Panel Report

Knox Planning Scheme Amendment C141

Upper Gully Strategic Plan

21 December 2016

Figure 1 Exhibited DDO12 Upper Ferntree Gully Activity Centre

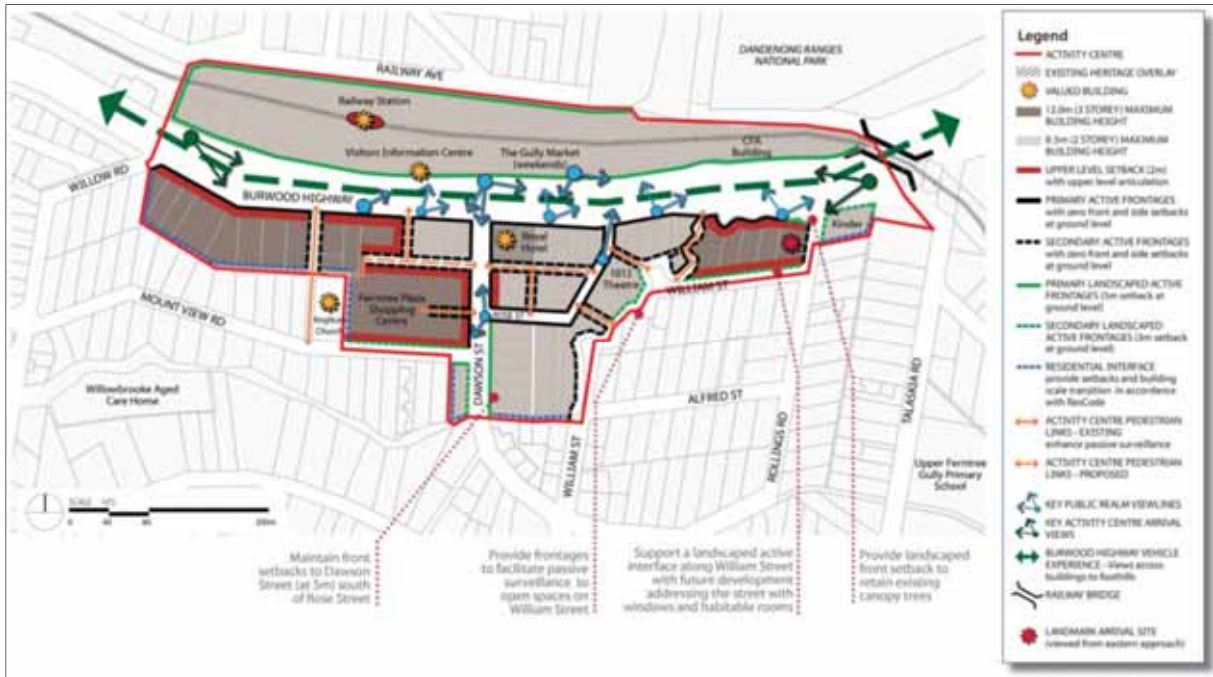
The Amendment applies to land in the shaded area shown in Figure 1. Figure 1 shows design and development plan for the Upper Ferntree Gully Activity Centre, as exhibited (DDO12 Map 1).

Figure 2 Post-exhibition changes to DDO12

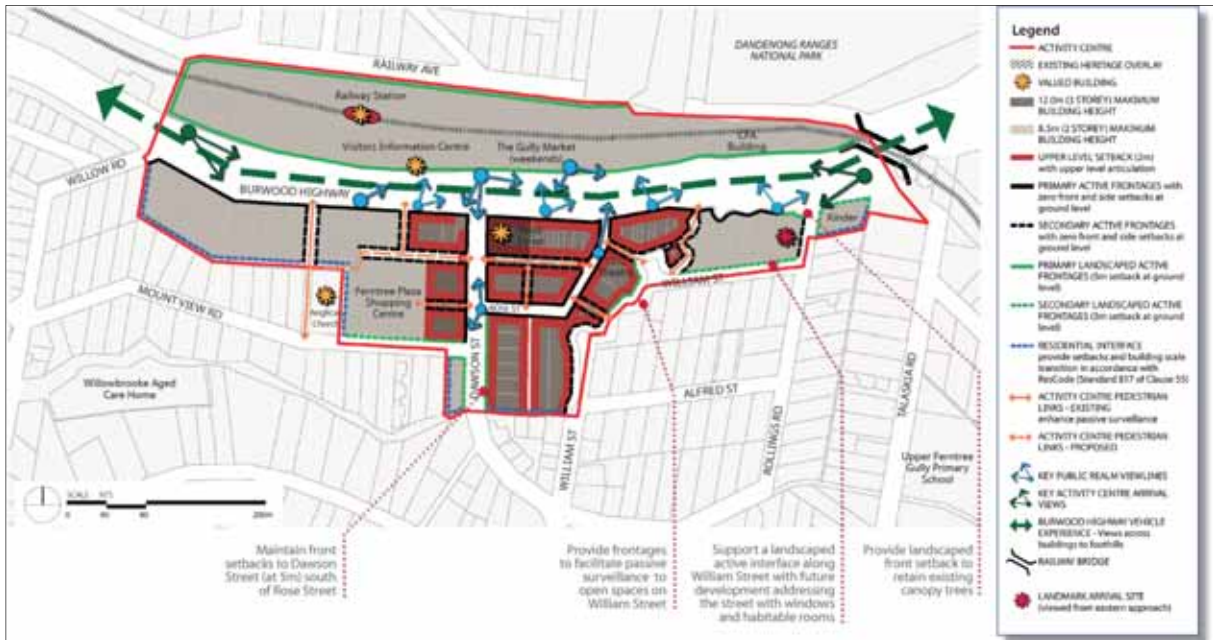
Following its meeting on 28 June 2016, Council decided to change the exhibited heights, as shown in Figure 2.

Figure 3 Upper Gully Strategic Plan – Preferred setbacks and design outcomes for built form

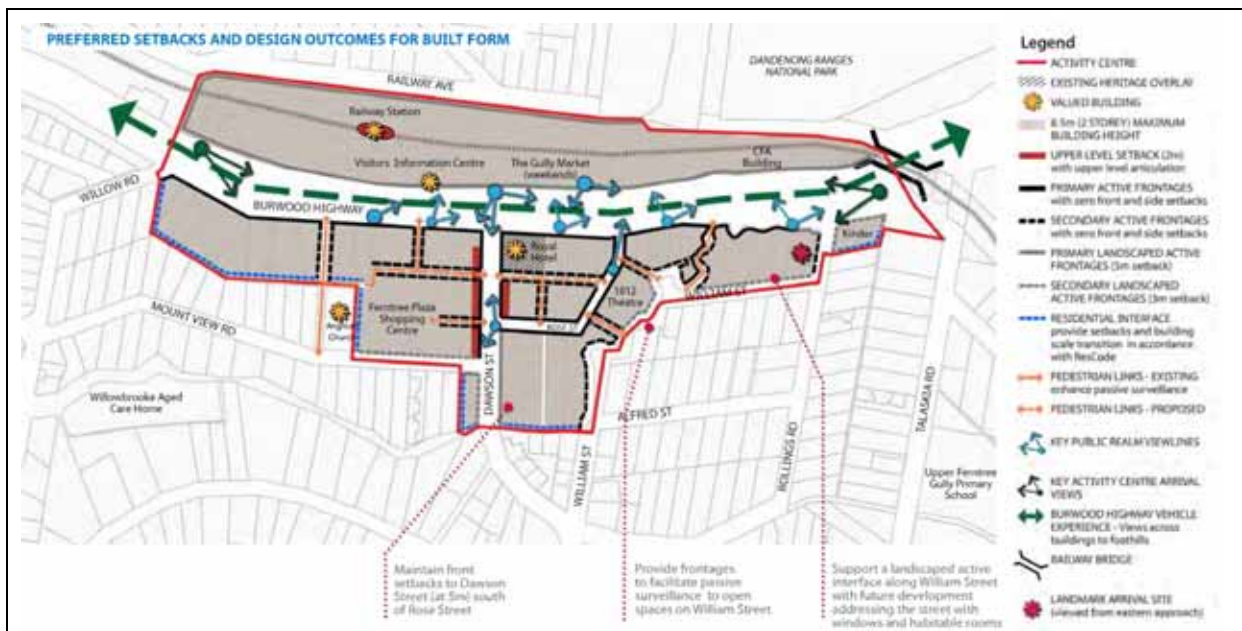
The exhibited Strategic Plan mirrors the Gully recommended pre-exhibition version except for the preferred setbacks and design outcomes for built form. The original Strategic Plan, October 2015 included preferred setbacks and design outcomes for built form, as shown in Figure 3. It proposed a mandatory maximum 8.5 metre building height to the entire Activity Centre.
